# UNITED STATES PATENT AND TRADEMARK OFFICE

10/705,899

| <b>Office Action Summary</b> | <b>Application No.</b><br>10/705,899 | <b>Applicant(s)</b><br>LEE ET AL. |  |

## DETAILED ACTION

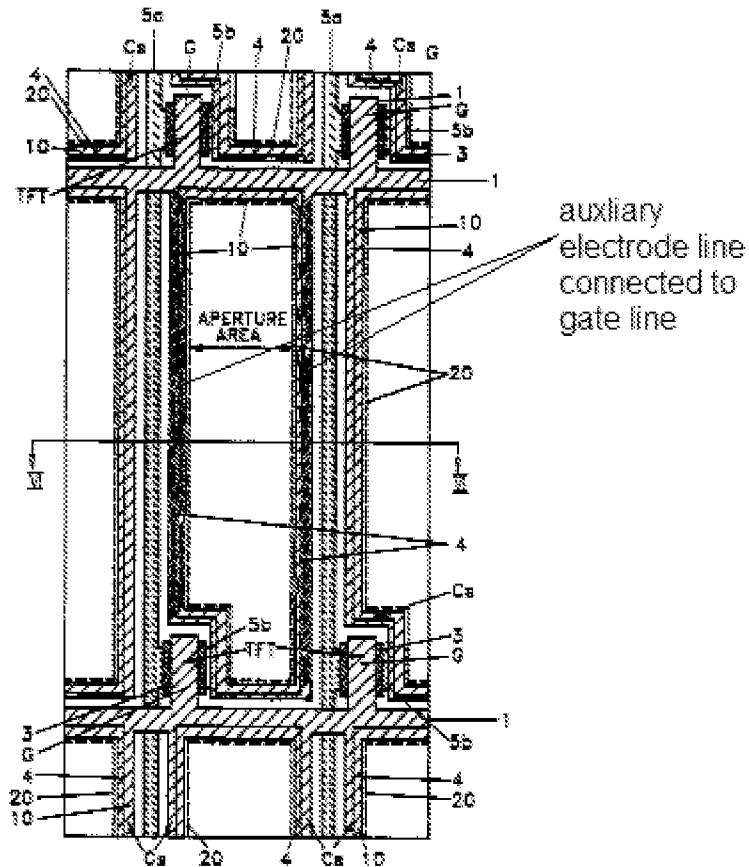
In regard to claim 1, Kim et al. disclose (Figs. 3G-J) a multi-domain liquid crystal display device comprising:

- a liquid crystal layer between the first and second substrates;
- a plurality of data lines 5a for applying a data signal on the first substrate;
- a plurality of gate lines 1 for applying a gate signal, the gate lines crossing the data lines to define a plurality of pixel regions, wherein each pixel region has a multi-domain structure which includes a dielectric structure (layer 6 made of silicon nitride);

- a thin film transistor near each crossing of the gate lines and the data lines;
- a common electrode 17 on the second substrate;
- a pixel electrode 13 connected to a drain electrode of the thin film transistor in each pixel region; and
- an auxiliary electrode line 15 electrically connected to at least one of the common lines in each pixel region, the auxiliary electrode line and the multi-domain structure distorting an electric field applied between the common electrode and

the pixel electrode to thereby form at least two domains in each pixel region during an operation of the multi-domain liquid crystal display,

- the auxiliary electrode line is formed between the pixel electrode and the data line at an outside of the pixel electrode in the pixel region and the auxiliary electrode is not overlapped with the data line.

- the auxiliary electrode line is formed in the same layer as the gate lines.
